ENGINEER MELLINGER	DATE 27 AUG 92	MONTEREY BAY AQUARIUM RESEARCH INSTITUTE 160 Central Avenue Pacific Grove, CA 93950
CHECKED MATTHEWS	DATE 11 SEPT 92	
APPROVED	DATE	IBC REGEN CONTROLLER
APPROVED	DATE	
APPROVED	DATE	
PWB NO. 4131	SIZE D	FSCM NO	DWG NO 4132
ASS'Y NO. 4130	SCALE		SHEET
December 17, 1992

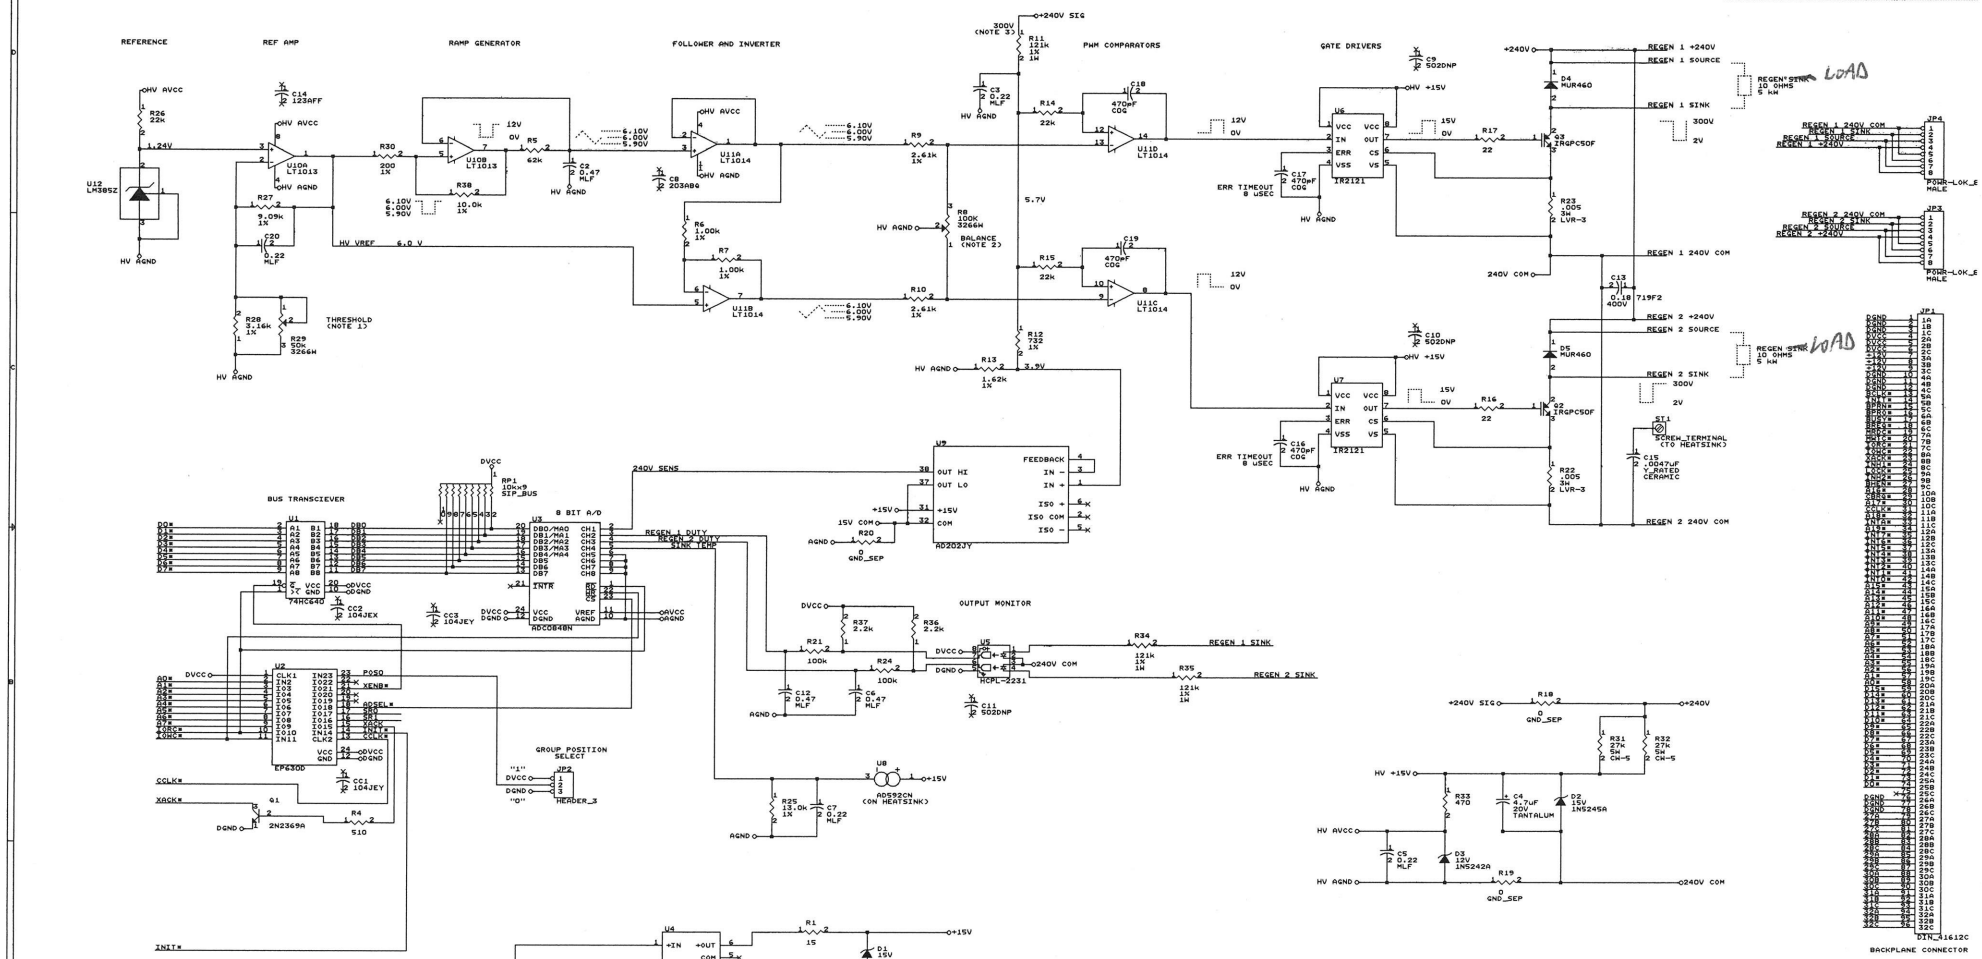
REV	CHANGE	INITIAL
01	U6,7 INPUT GROUND TO HV AGND	ECM
02	CORRECT P3, P4 PINOUTS	ECM
03	CHG R31,32 FOR AVAILABILITY	ECM
04	CHG R28 FOR INCREASED ADJ RANGE	ECM
